PLANNING, PROTECTIVE SERVICES AND LICENSING COMMITTEE 22 January 2020.

REFERENCE: 19/01498/MPLAN

LAND NORTH WEST OF GLENCRUITTEN RISE, OBAN: PDA 5/3, PDA 5/6 and PDA 5/7

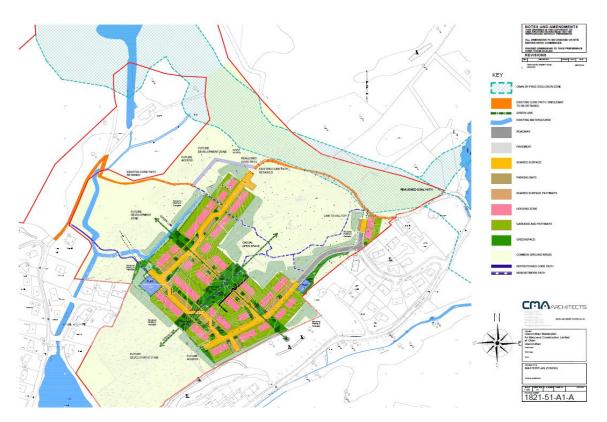
Officers were concerned that the initial approach to developing the site, set out in the original Masterplan layout, resulted in an overly linear and suburban style street. Essentially the proposal was for a long single street forming a" horseshoe" shape, with relatively continuous built form and a very urban character. In Officers view this did not follow the advice set out in the Council's approved design guidance for major Housing development nor the Scottish Governments advice in respect of "Placemaking" in respect of the proposed urban form.

The amended general layout avoids an overly linear and single aspect development. It also provides the opportunity to integrate significant landscaping around and within the layout to soften its appearance and improve the urban form in respect of amenity. The perceived density of the building form can be substantially reduced both by careful layout and orientation within the general layout approach, but also by the use of open space and landscaping within and

around the development to substantially soften its appearance and assist its integration in the its surroundings.
